# Consultation report of the Public consultation on the scenario's, sensitivities and data for the CRM parameter calculation for the Y-4 Auction with Delivery Period 2025-26

June 2020

Figure 4: Analysis of the nuclear unavailability in France during winter months in France for the appropriate sensitivities selection

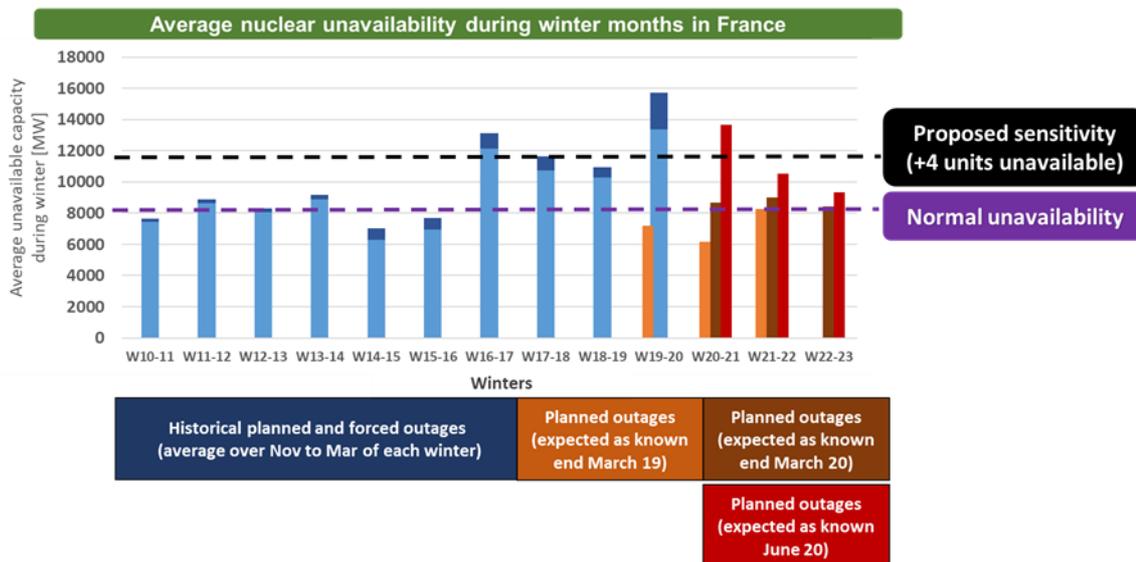
- The nuclear fleet is ageing and several reactors need longer downtimes for their '4th Decennial inspections';
- More stringent safety rules might require additional unplanned works/upgrades during those downtimes;
- Common mode failures (e.g. issues found in one reactor which can affect more than one nuclear unit due to their similar design) are likely to occur as observed in the past.

Therefore, in this sensitivity (if integrated in the reference scenario), it is suggested to

remove 4 units from the nuclear capacities defined in the dataset of MAF2019 for the winter period 2025-26 (as this corresponds to the observed increased average unavailability during winter in the past 4 winters in France). It is therefore neither foreseen to look at the French security of supply nor to assess the performance of a CRM abroad in the framework of the CRM calibration.

This sensitivity on the nuclear availability in France is proposed in order for the Belgian authorities to cover themselves against lower nuclear availabilities in France as experienced in the most recent winters. Such reasoning is compliant as it is justified and quantified as described in the explanatory note, in line with article 4, §4 of the Proposed Royal Decree.
